**LEBANON PLANNING BOARD
DECEMBER 9, 2024 - 6:30 PM
COUNCIL CHAMBERS, CITY HALL OR
REMOTE VIA VIRTUAL PLATFORM
LEBANONNH.GOV/LIVE**

Staff Memorandum – PB2024-22-SPRCUP – *con't from 11/12/24*

Site Plan Review and CUP for a proposed 474-unit multi-family PURD, and a CUP to allow an increase in the maximum permitted building height from 45 ft. to 55 ft.

- ▶ Plan set titled “The Brickyard Residential Development,” dated May 10, 2024, latest issue December 4, 2024, prepared by VHB, EV Project: 52933.00 (53 sheets plus cover sheet)

Utility Plan 1

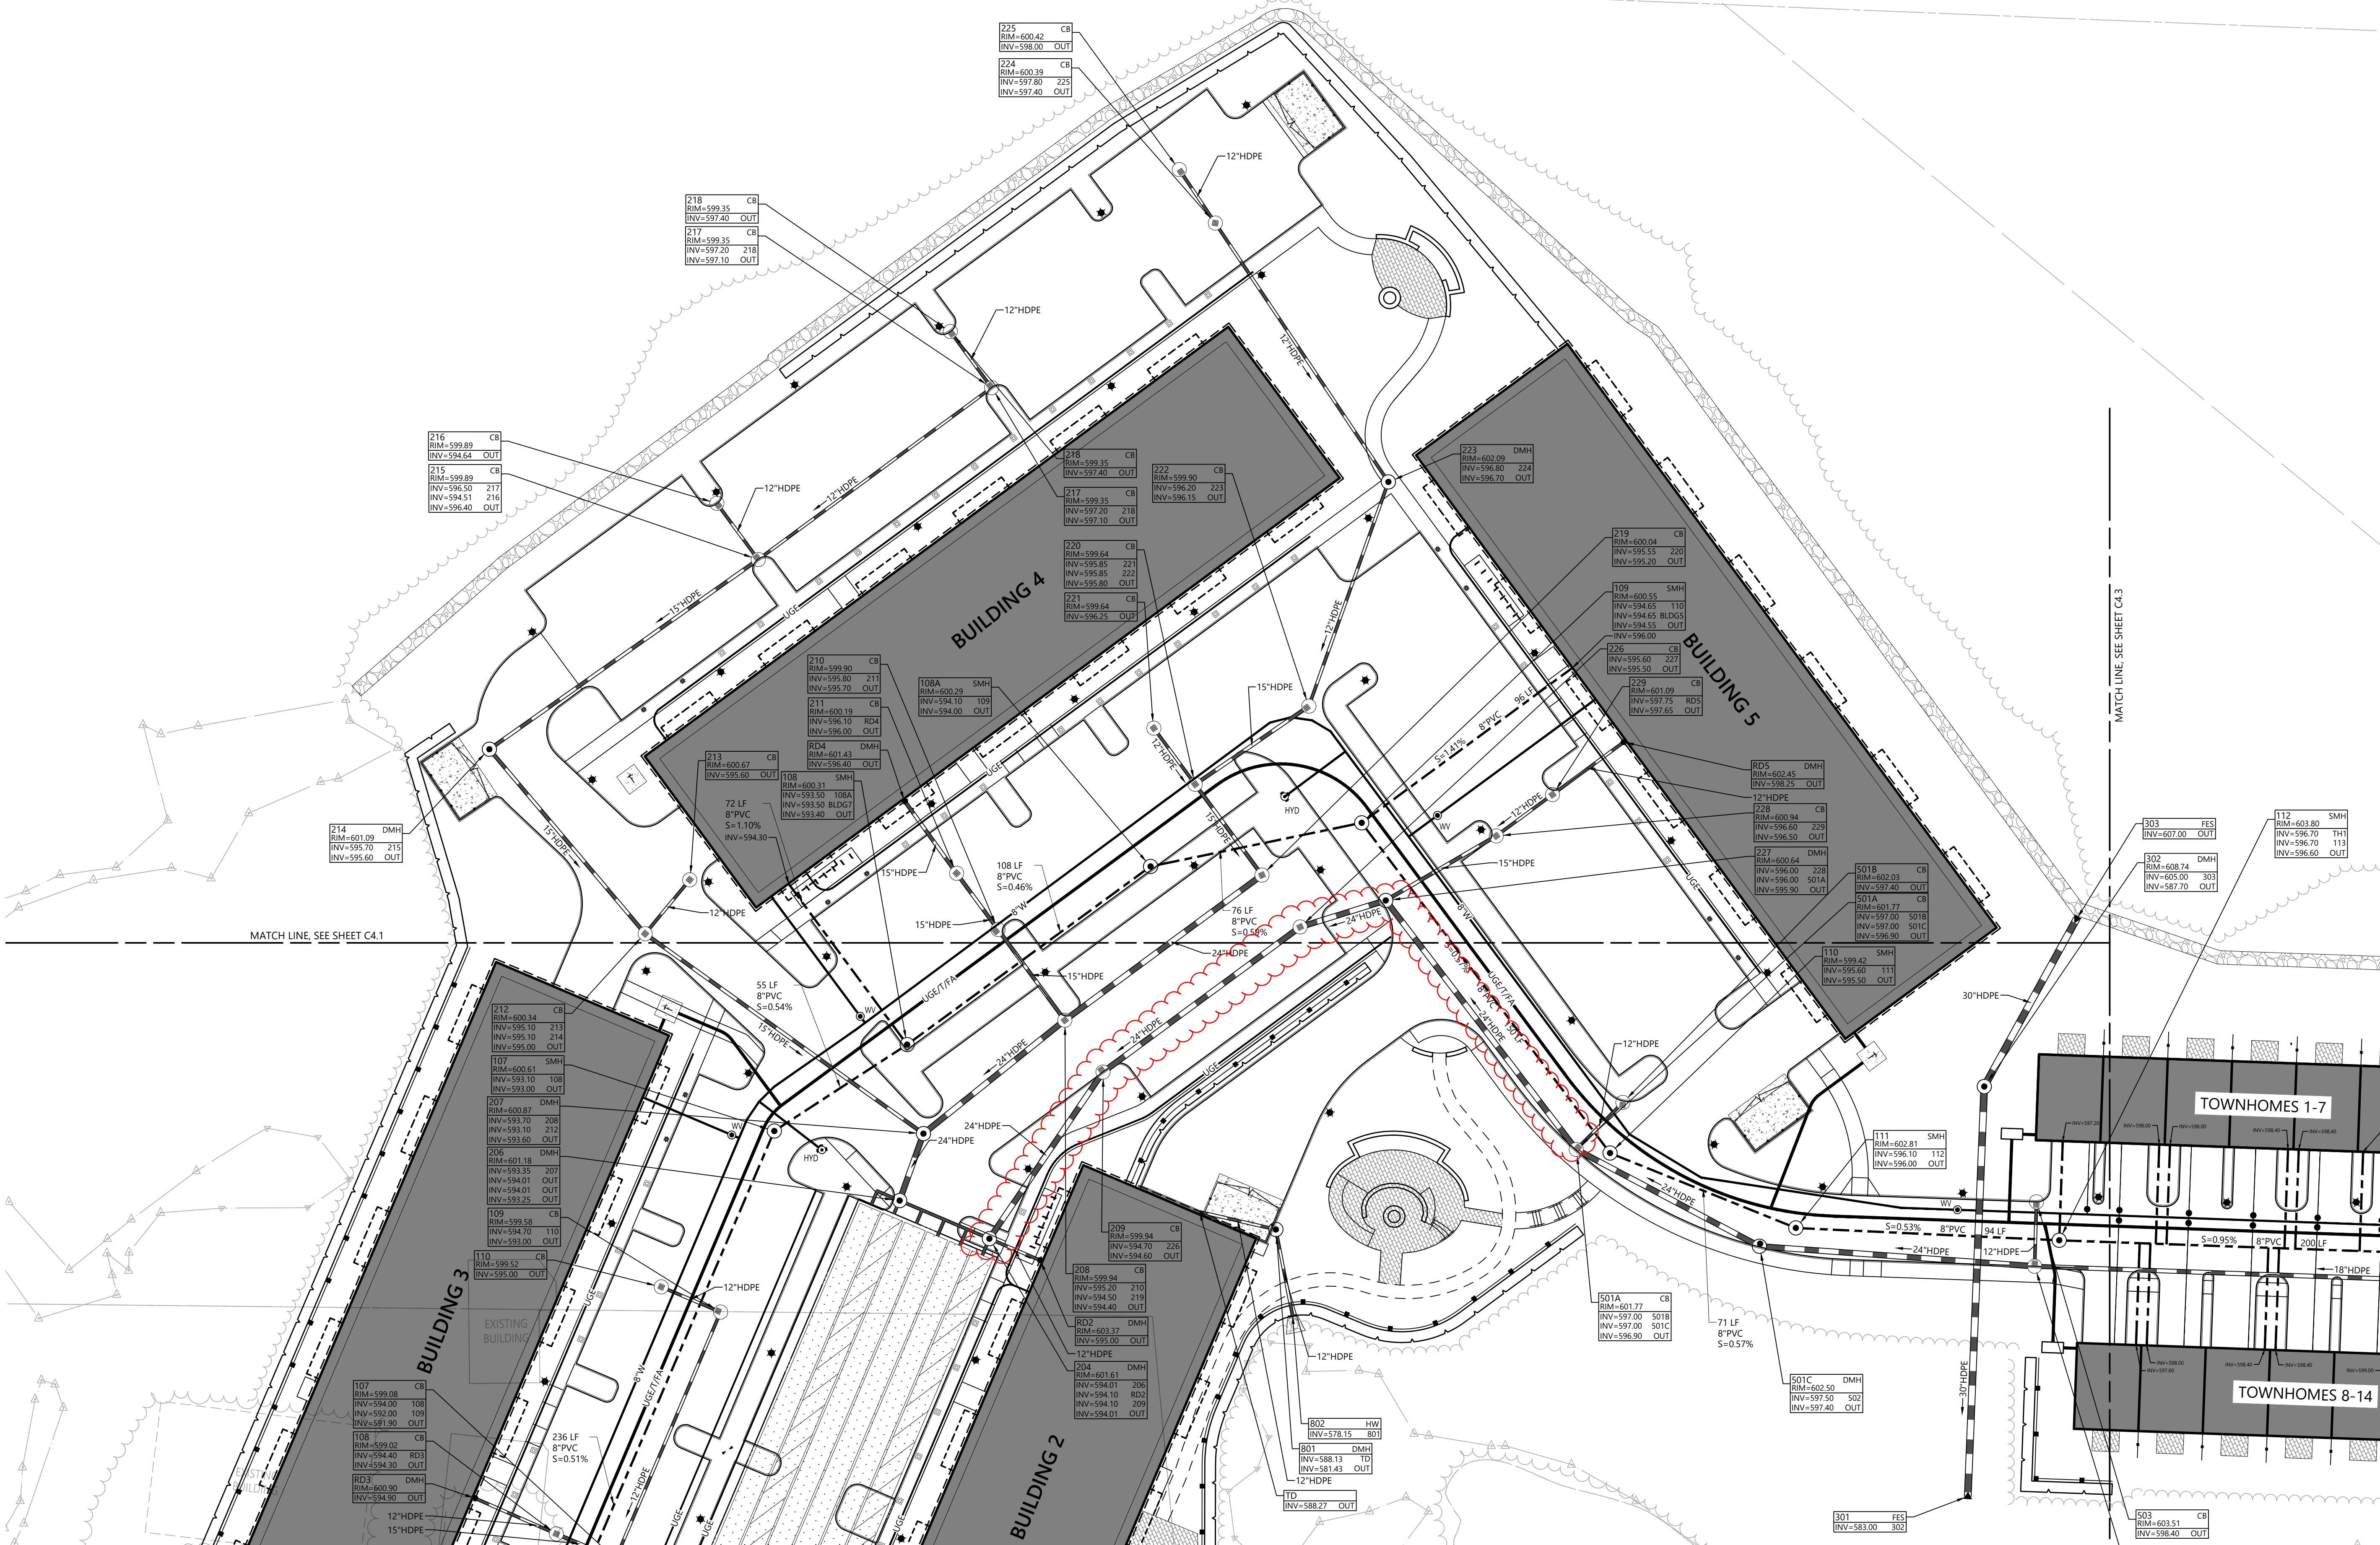
- b. We continue to recommend labeling proposed sluice construction on Sheets C3.2, C3.3, C4.2 and C4.3 respectively, as applicable.
 - c. We recommend the drawings identify the intended disposition of two existing 60-inch diameter and one existing 54-inch diameter culverts located in the vicinity of Building 1 (See Sheet C4.1).

- b. We recommend a vertical drop in invert elevation of not less than 0.1-foot over the width of any sewer manhole. While a vertical drop of 0.1-feet is specified at most locations, there are others (Example: SMH 108 — Sheet C4.1) where invert-in and invert-out elevations match or are less than 0.1-feet. We recommend revision.

Not Approved for Construction
Drawing Title
Utility Plan 3

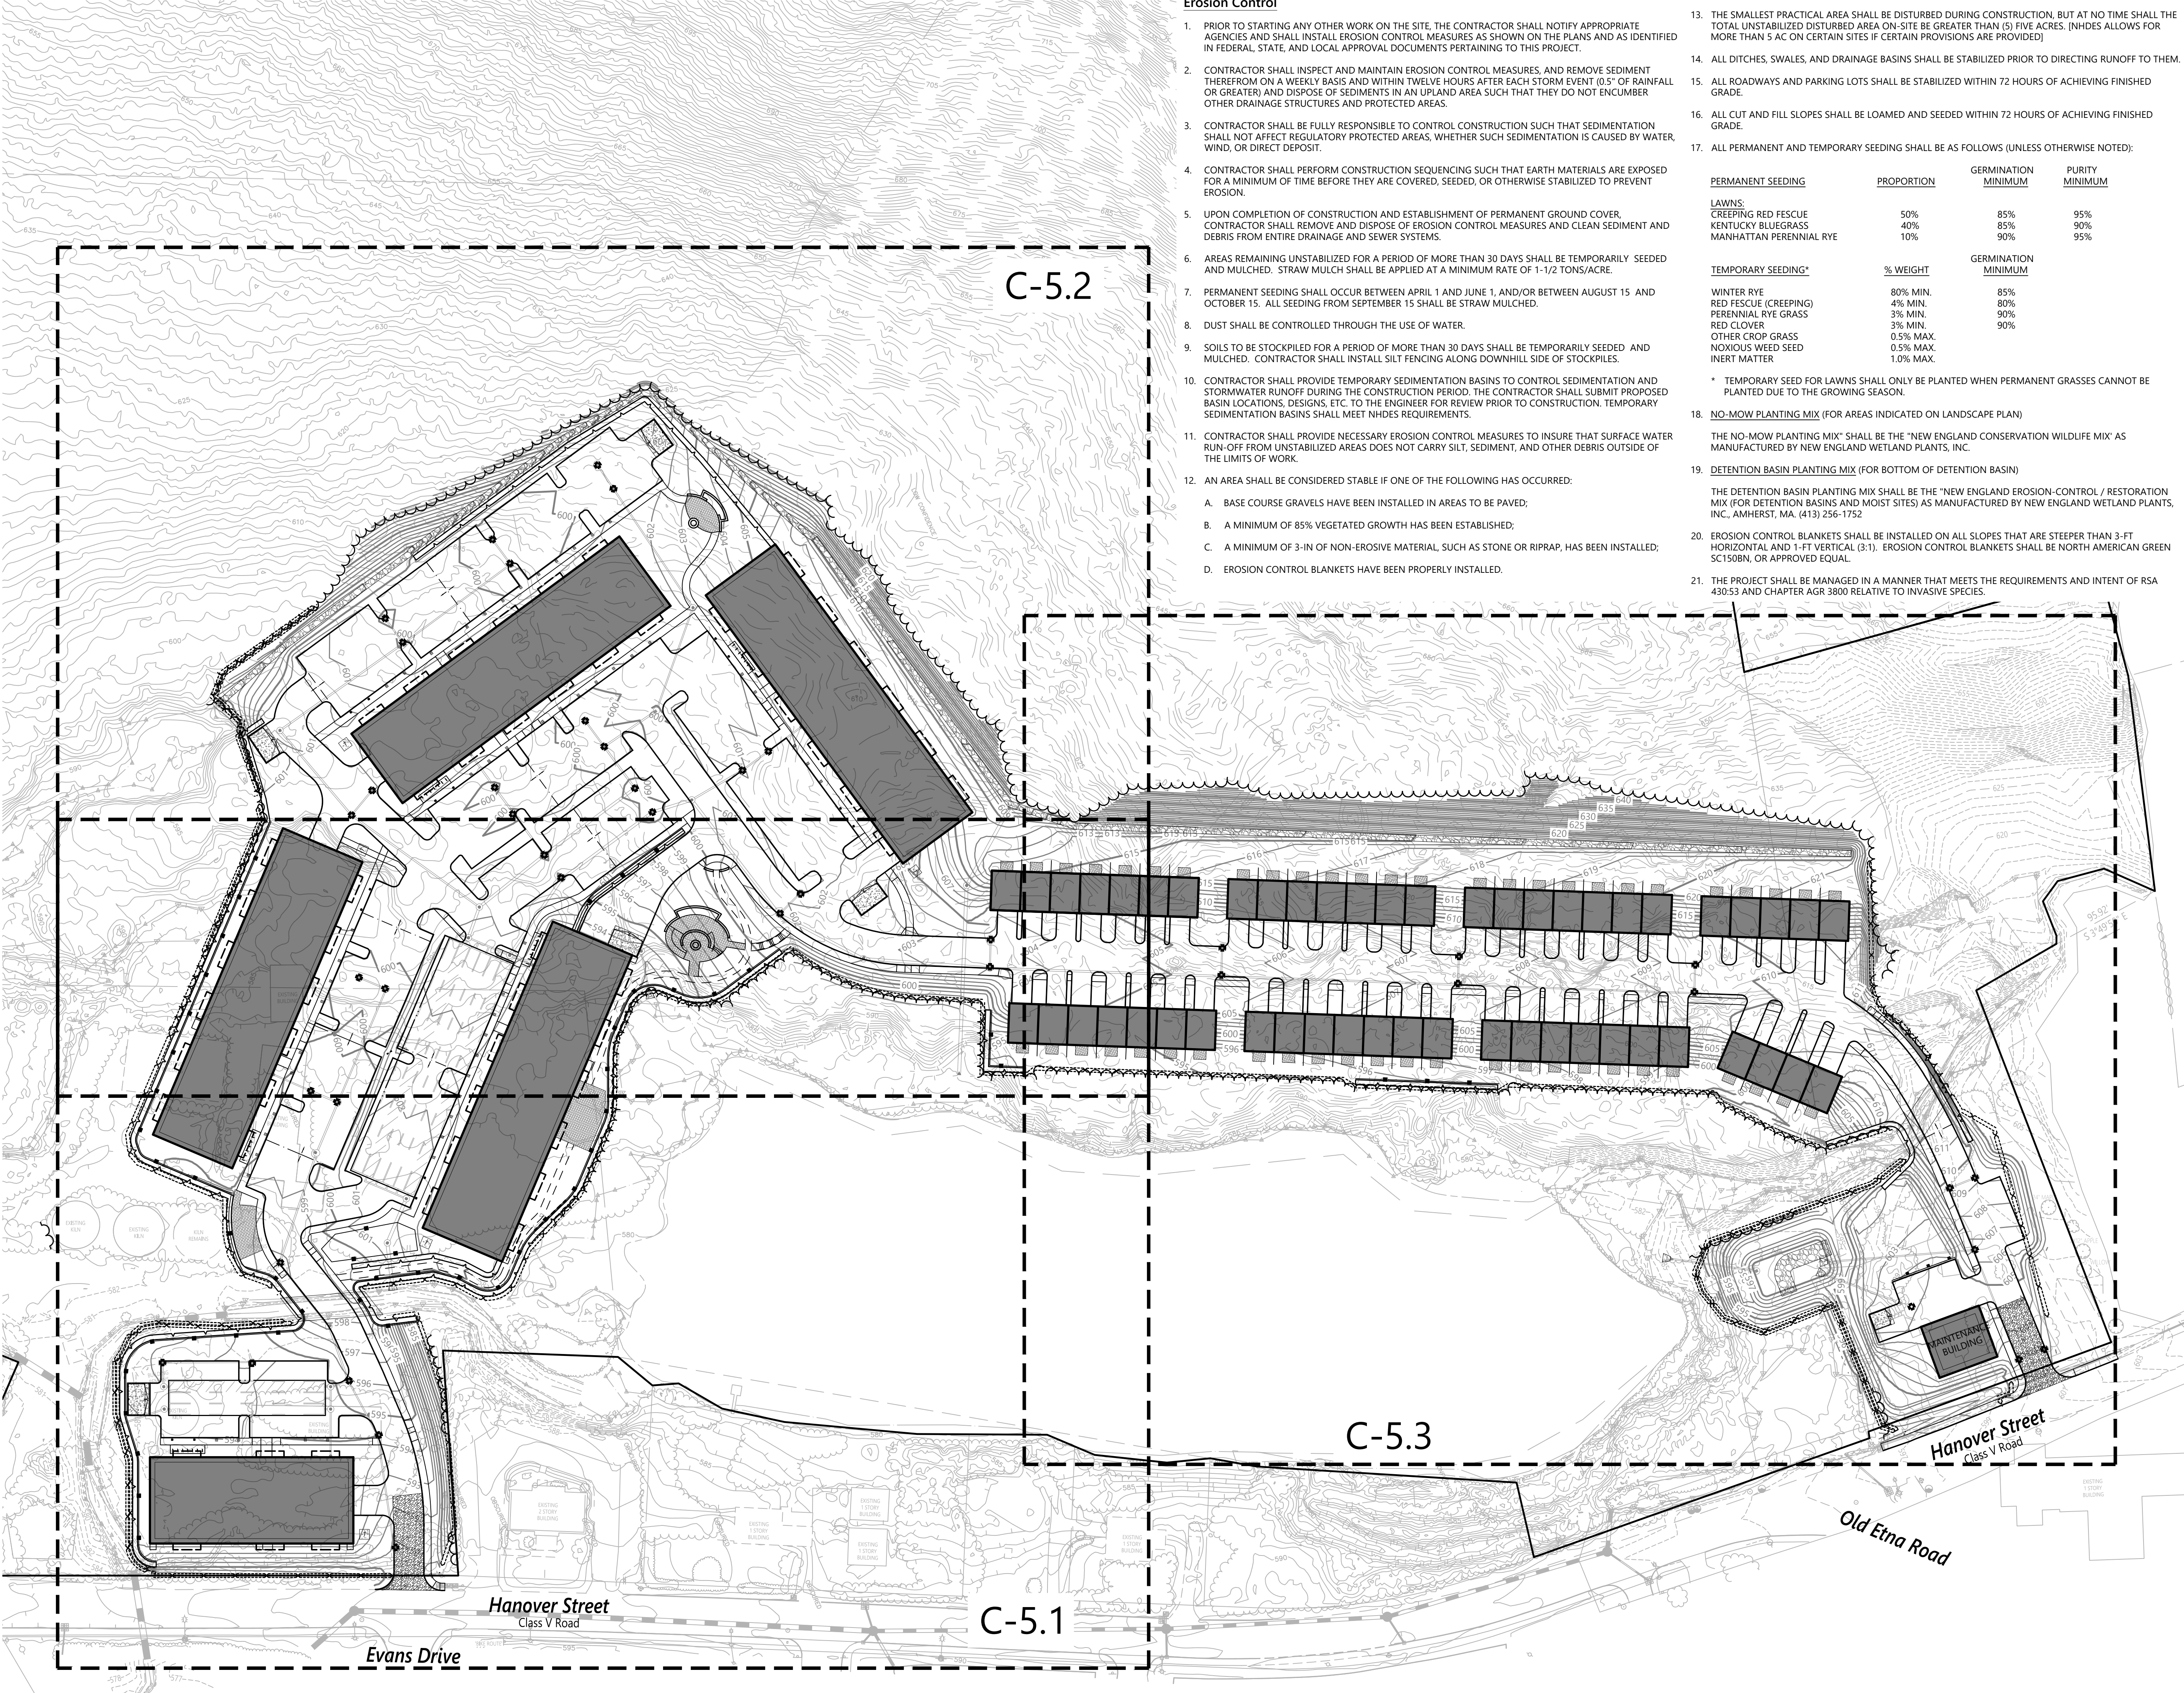
- c. We recommend the expansion of Sheet C4.2 and C4.3 to specify pipe diameter, slope, and length values for segments of proposed sewer connecting the planned townhomes.
- d. We continue to recommend the addition of a label on the profile on sheet C6.1 at about station 5+25 to ensure an 18" separation between the water and the sewer line.
- e. We continue to recommend the addition of a typical sanitary sewer trench detail to the drawings.
- f. The drawings note proposed sewer will be constructed with PVC pipe. We continue to recommend expansion of the drawings to indicate PVC pipe and fittings incorporated with sewer construction shall be SDR 35 PVC.
